Re: Oconee Unit 2
Docket No. 50-270

Revision 2 to Babcock and Wilcox BAW-1425, "Oconee 2, Cycle 2 Reload Report," is attached to reflect the above changes in analytical method and results.

REVISION 2 TO
BAW-1425

OCONEE 2, CYCLE 2 RELOAD REPORT

Table 6-1. Cycle 1 and 2 Maximum Design Conditions

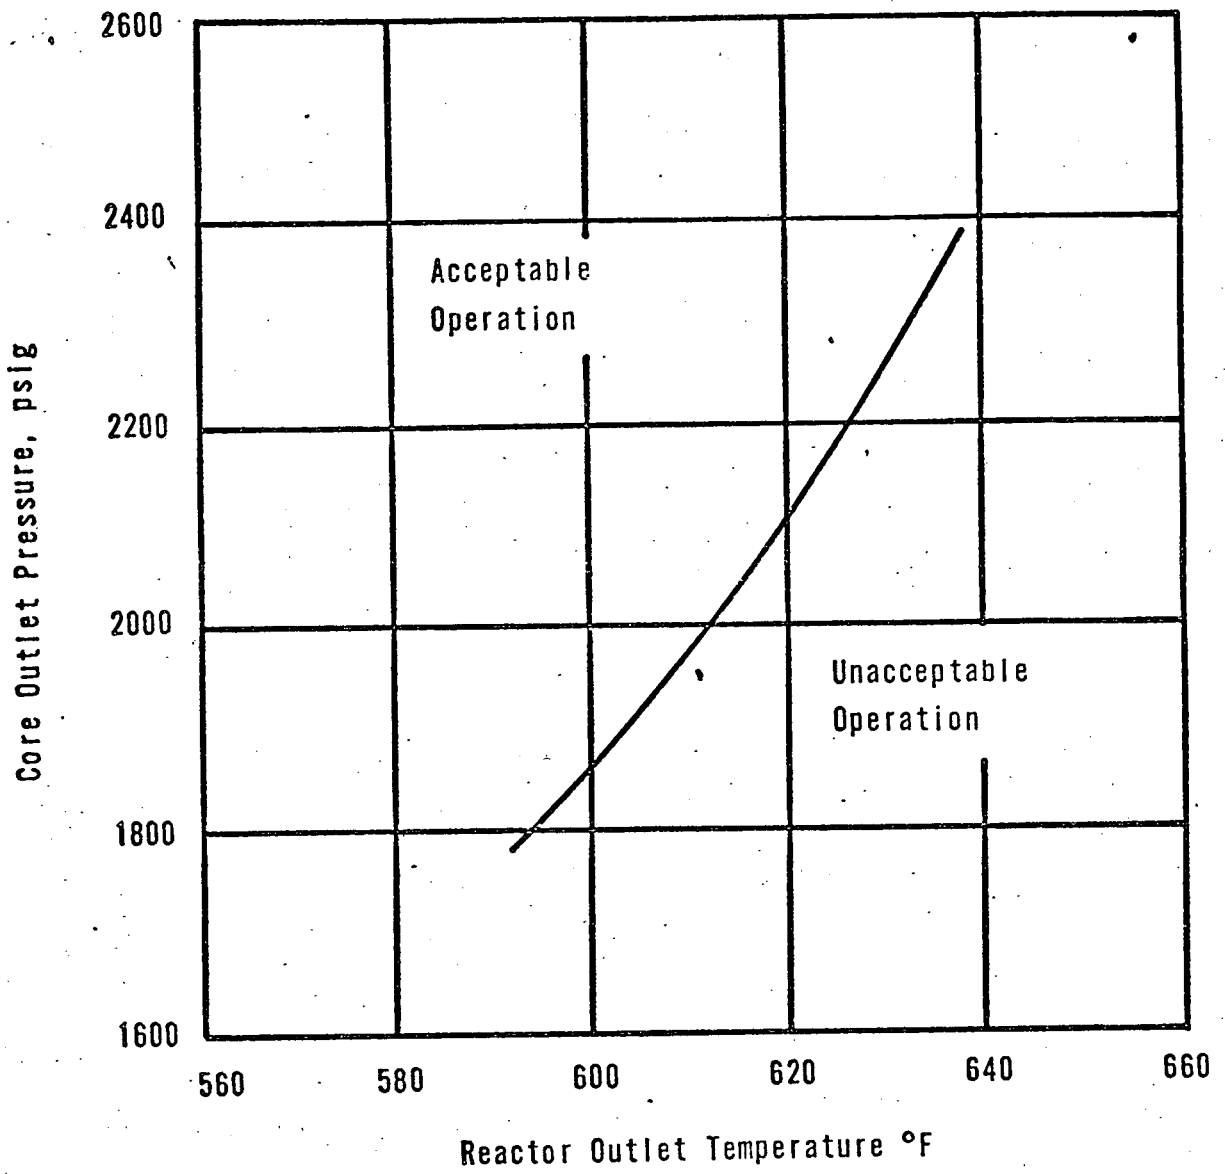
used in the analysis are 1.087 and 3.10 inches, respectively. The results of the two effects are -5.93% and -3.47% change* in the minimum hot channel DNBR and peaking margin, respectively. The changes in these margins are summarized in Table 6-1, which includes comparisons of other pertinent cycle 1 and 2 data. | 2

UNIT 2 CYCLE 2
CORE PROTECTION SAFETY LIMIT
Figure 8-1

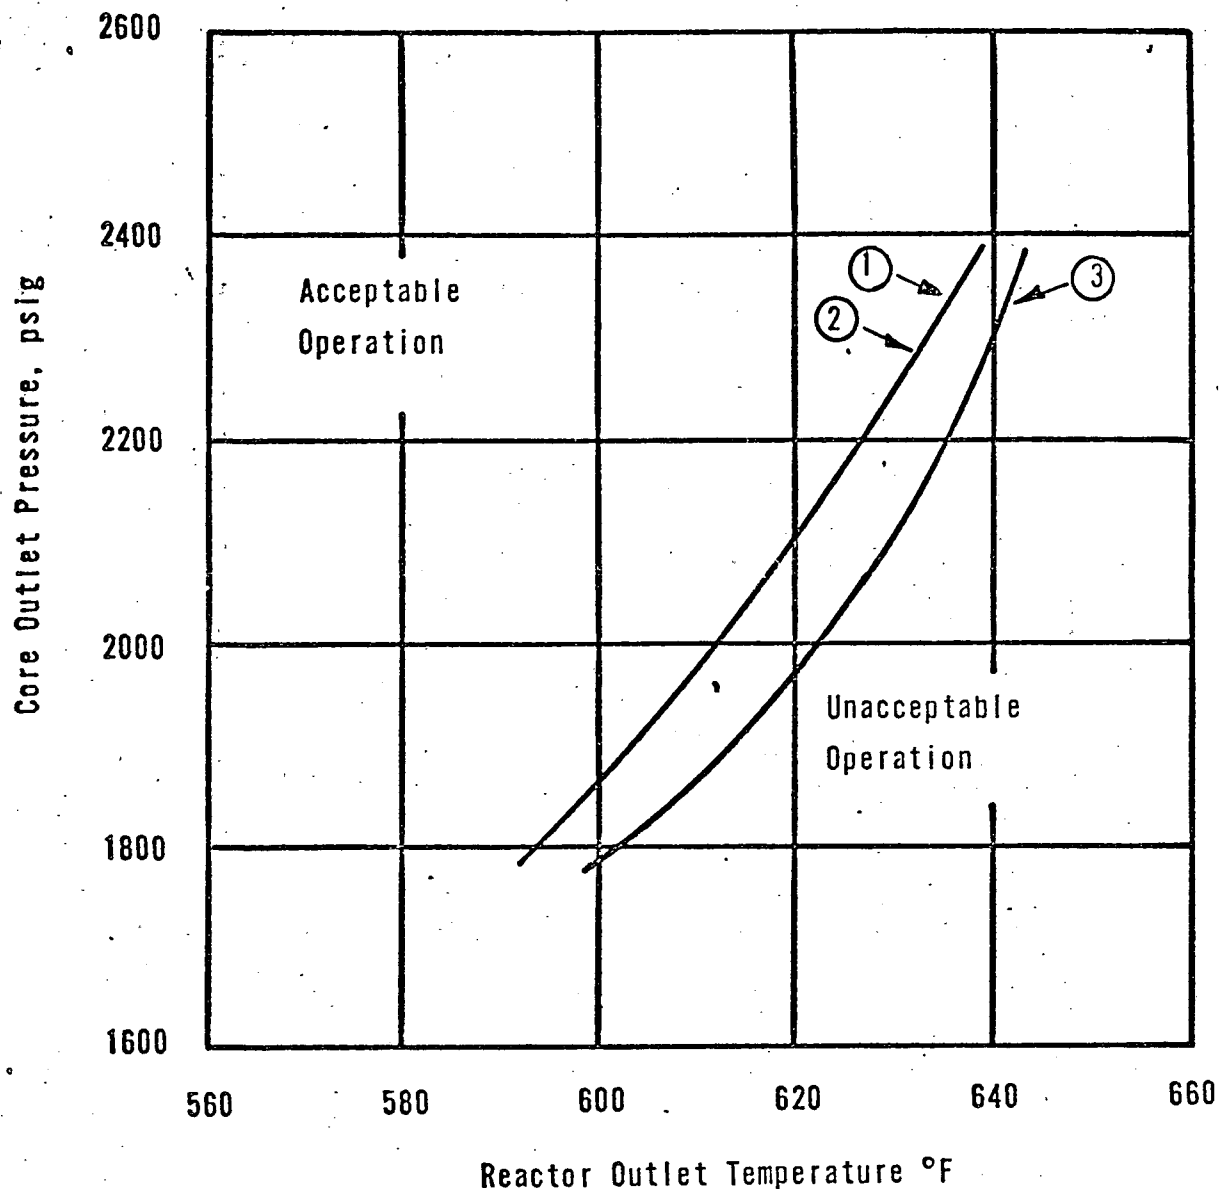
Based on the Technical Specifications derived from the analyses presented in this report, the Final Acceptance Criteria ECCS limits will not be exceeded, nor will the thermal design criteria be violated. Figures 8-1 through 8-14 illustrate revisions to previous Technical Specification safety limits.
